Professional Audio Service Bulletin

Bulletin No. 20

Modification To Mute Signal Electronics When In Stop Mode

8, 16 and 24 track M-79 recorders

STOP MUTE MODIFICATION

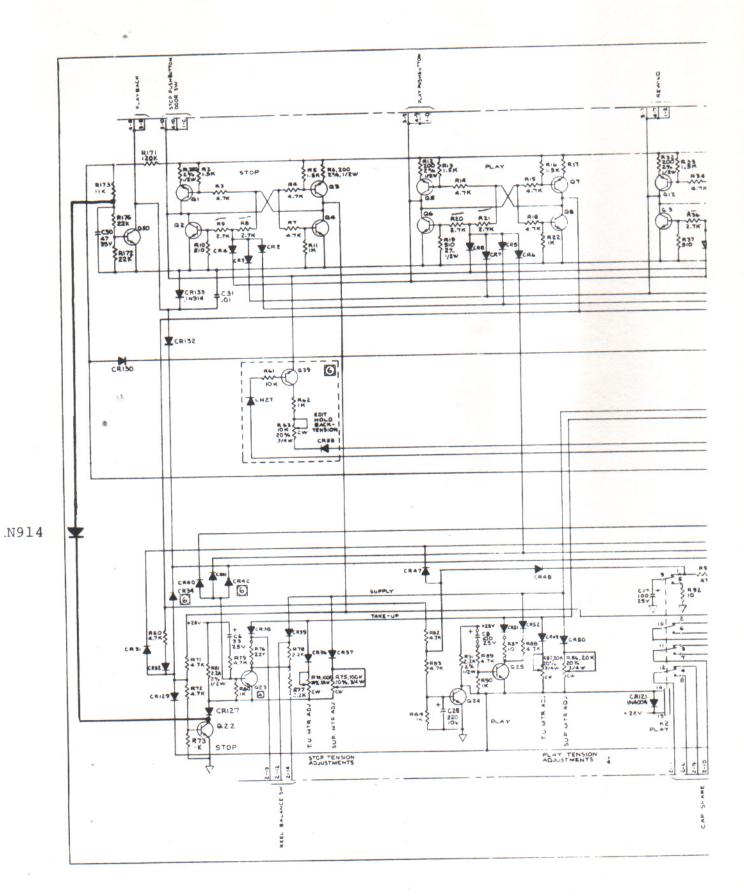
- 2) Install 1N914 diode from collector of Q-22 to junction of R-173 and R-176. (cathode of diode to collector of Q-22) see Fig. 1. Use tubing on leads of diode.
- 3) Install logic pc board into recorder.
- 4) Thread a roll of tape onto the recorder which has a signal recorded on it and press stop button.
- 5) Manually move tape back and forth. Signal from tape should not be heard nor appear on meters.
- 6) Press mute defeat switch and repeat step five. Signal should be heard and should appear on meters.
- 7) This mod will not effect the monitoring of input signals.

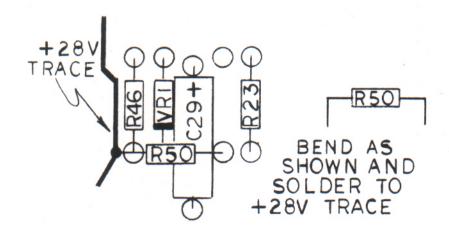
1. Remove R50.

2. Install 20K ohm resistor as shown in figure 1.

Replace VR1 with 12V Zener
